## Recycling Facility and/or Recycling Containment

1.  
Operator: Enduring Resources IV, LLC (For multiple operators attach page with information) OGRID #: 372286  
Address: 200 Energy Court, Farmington, NM 87401  
Facility or well name (include API# if associated with a well): KWU 2309-30D  
OCD Permit Number: 3RF-39 (For new facilities the permit number will be assigned by the district office)  
U/L or Qtr/Qtr NWNW Section 30 Township 23N Range 9W County: San Juan  
Surface Owner: ☒ Federal ☐ State ☐ Private ☐ Tribal Trust or Indian Allotment

**From:** Smith, Cory, EMNRD  
**Sent:** Thursday, November 8, 2018 8:00 AM  
**To:** 'Andrea Felix'  
**Cc:** 'Lacey Granillo'; James McDaniel; Fields, Vanessa, EMNRD; Powell, Brandon, EMNRD  
**Subject:** RE: Enduring Resources KWU 2309-30D location: Onsite Request

The recycling containment does not meet the siting requirements as specified in 19.15.34.11.A(2) NMAC and therefore has been Denied.

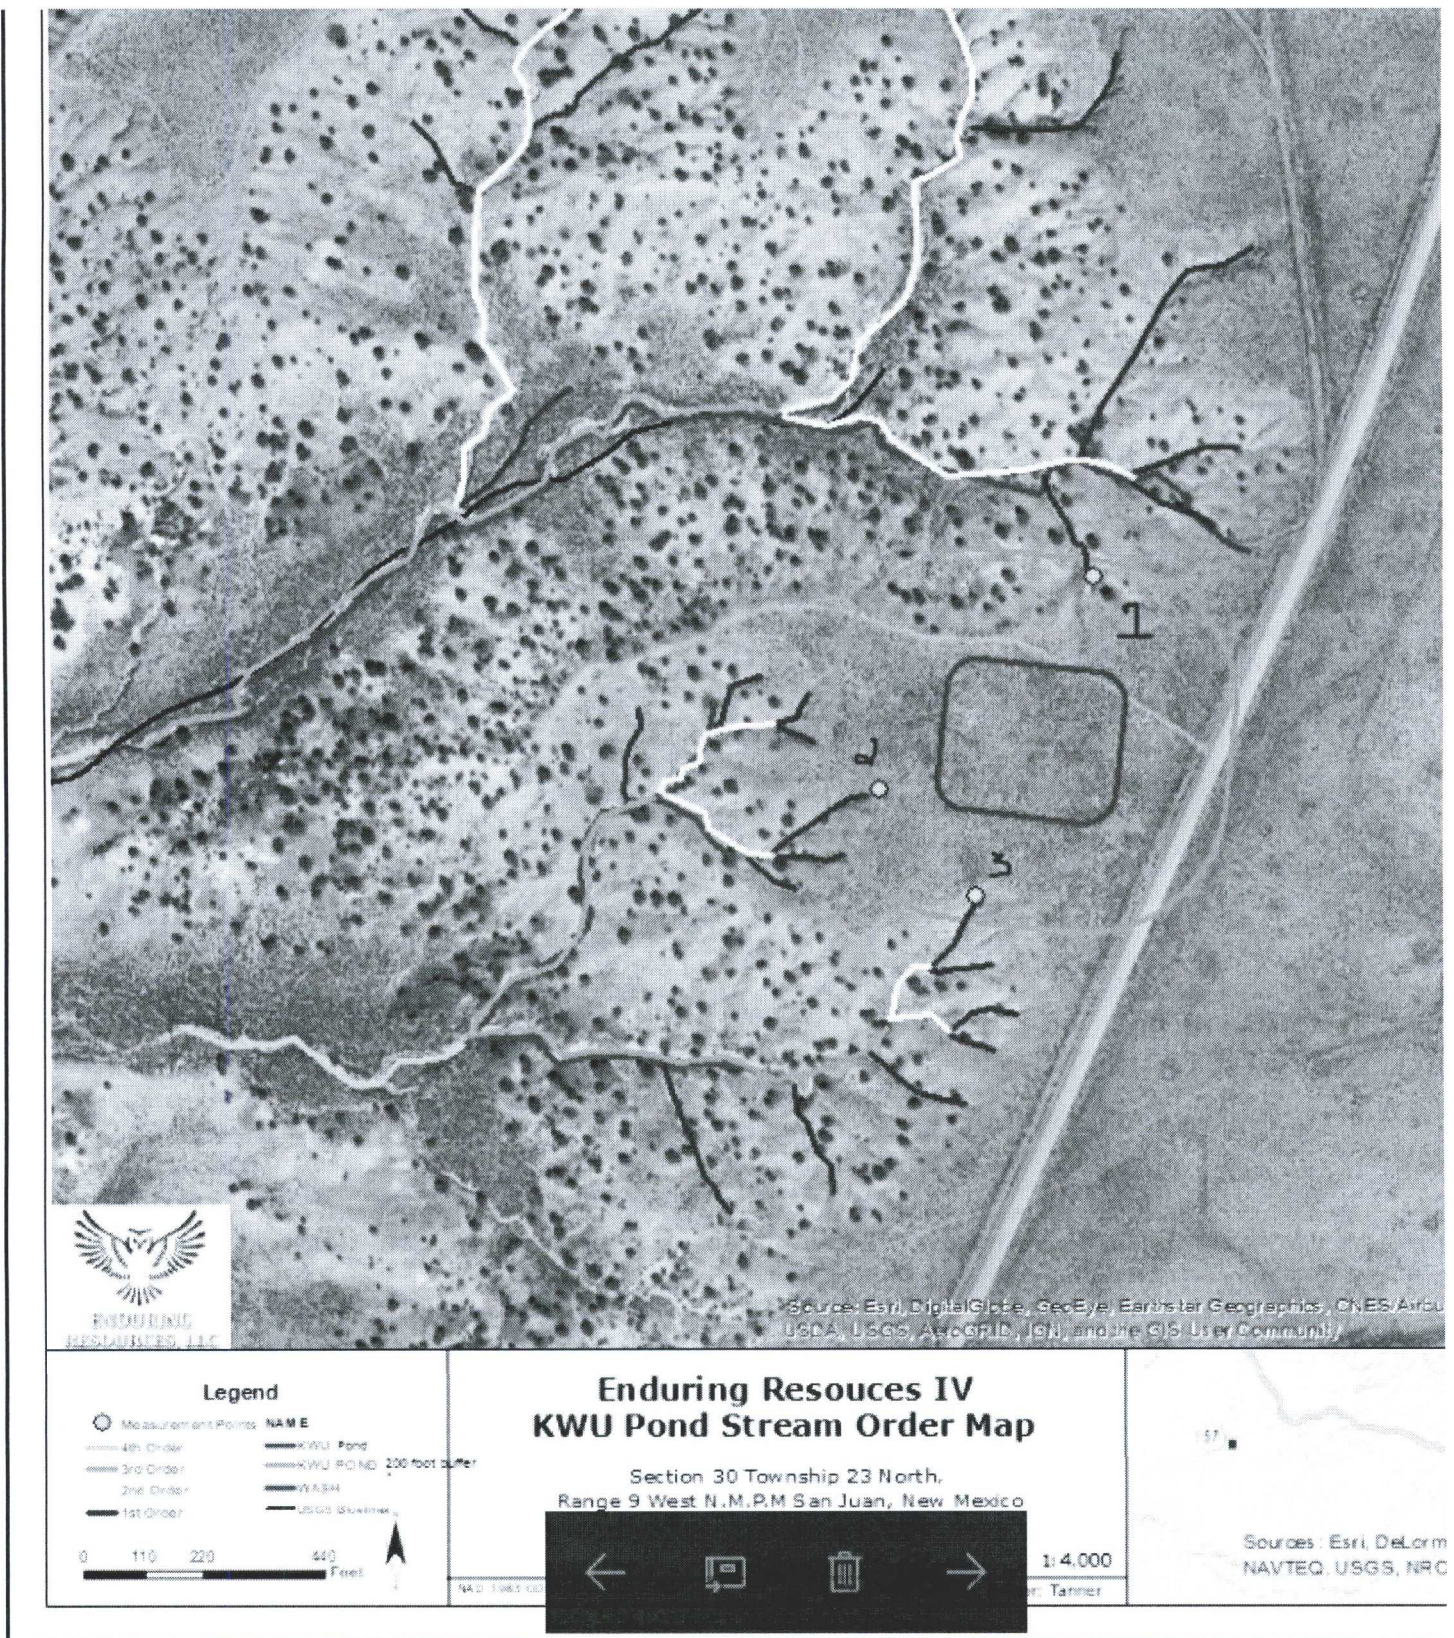
OCD performed onsite inspection on October 26, 2018. Please reference the provided map with areas marked 1, 2, and 3.

Area 1, North of the pond looking Back towards Pond location.

Start of significant water course with a defined bed and bank, 36.204223 -107.836581 within 200'

Area 2 West side of Pond (Midpoint) facing east towards the pond start of defined bed and bank 36.203353  
107.838422

Area 3 South corner of pond facing West at the (Orange flag is edge of pond)

At edge of pond facing west

After performing an onsite inspection the OCD believe this location does not meet the siting requirements of 19.15.34.11.A(2) NMAC. Enduring needs to either move the ponds location or request a variance and include a detailed written demonstration that the variance will provide equal or better protection of fresh water, public health and the environment.
